**Te Tupu Ngātahi**  
Supporting Growth  
PO Box 105218  
Auckland 1143

**Re: Response to request for further information in accordance with section 92 of the Resource Management Act 1991 for the South Frequent Transit Network Project.**

## Response to s92 request for further information

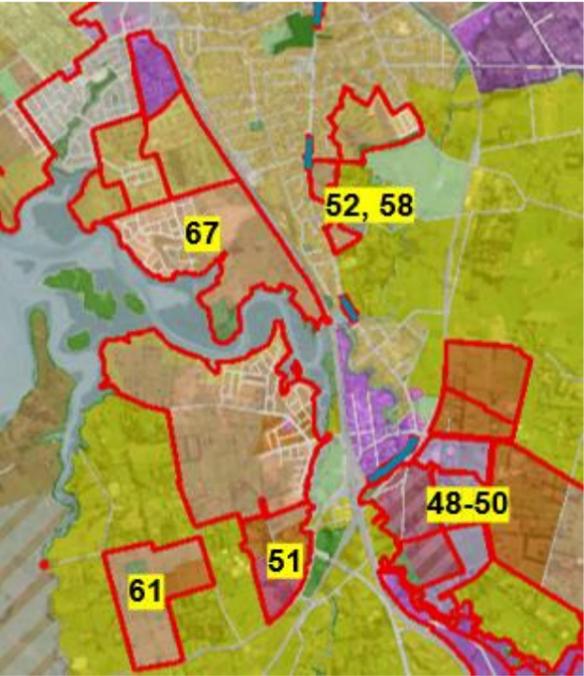
F2	<p>Can you please comment of the land required to construct and operate the stormwater treatment/attenuation ponds (e.g. NoR 3 and 4). For example being located in the floodplain, is attenuation a necessary outcome (leading to requiring pond construction), or would alternative devices located in the road reserve suffice to meet any water quality/retention and detention requirements.</p> <p><i>Rationale:</i> Information is required in order to better understand the use of land/designation extent.</p>	<p>The land requirement for attenuation is an intrinsically space requiring activity so the volume of water can be stored at the elevation where it is collected. We have gone to significant lengths to avoid locating these management areas where houses exist currently – i.e. locating in parks and right-to-drain easements. The floodplains and overland flowpaths, coincidentally are also in these areas, they can both be managed by balancing flowpath conveyance with the new wetland features through detailed design with the designation conditions as the guide on an acceptable outcome.</p> <p>Alternative devices are an option to achieve the water quality, retention and detention are available and have been used where a park is not available and designation of a house is not considered reasonable. In these cases, water quality, retention and detention can be achieved in a raingarden with attenuation achieved in an underground storage tank with a throttled outlet.</p> <p>The general process used to consider the appropriateness of alternative stormwater management devices is set out in section 3.2 of the Alternatives Assessment.</p>
